March 21, 1996

Subject: Byron Station Units 1 and 2  
Braidwood Station Units 1 and 2  
Supplemental Response to the NRC Request for Additional  
Information Regarding Ampacity Derating Analyses  
NRC Docket Numbers 50-454/455; 50-456/457

Fig. 2—Geometric factors for single-conductor cable and multi-conductor belted cable with round or sector conductors

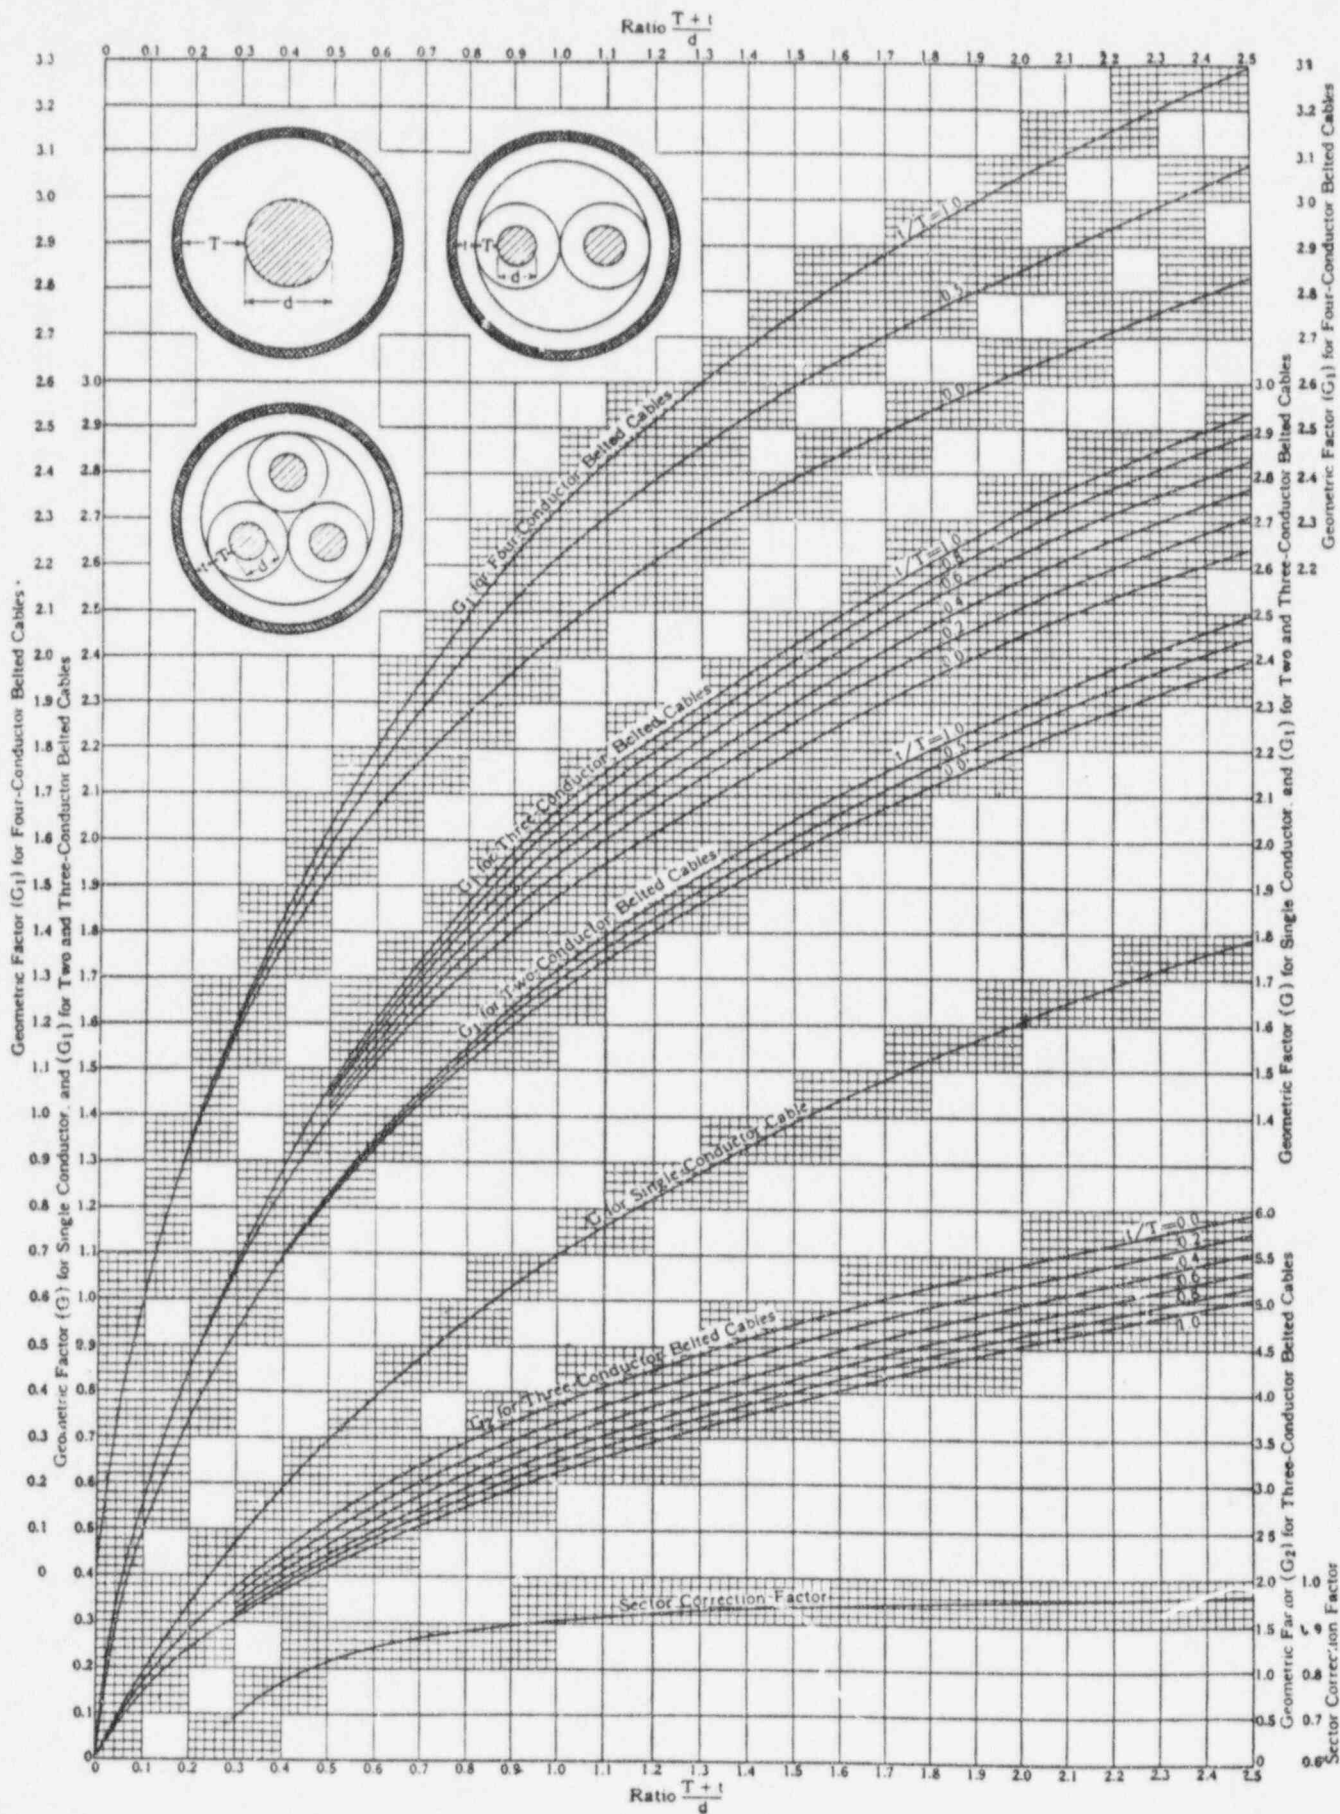
- 4) **Observation/Question(Ref.: Item 4, Page 5):** *"Given the information provided, the nature of the cable insulation and jacket resistance calculations are not clear. Specifically, the calculations presented as the top six lines of page 130 of Calculation G-63 require clarification. Although the calculations attempt to account for the cable insulation and jacket regions as annular regions, why are the multipliers of 2 and 3 applied to various parts of the resistance? How does the licensee justify simply adding the various components without consideration of parallel path heat transfer and the fact that heat is not flowing from the center of each conductor radially through each individual conductor, but rather non-uniformly through the multi-conductor cable as a whole?"*

where,  $G$  is a geometric factor that takes the non-uniform heat flow into account. The expression  $2 \ln \left( \frac{d_i}{d} \right)$  closely approximates the values of  $G$ , as can be seen in the plot of  $G$  taken from *Figure 2, page 13 of the D. M. Simmons paper<sup>2</sup>*.
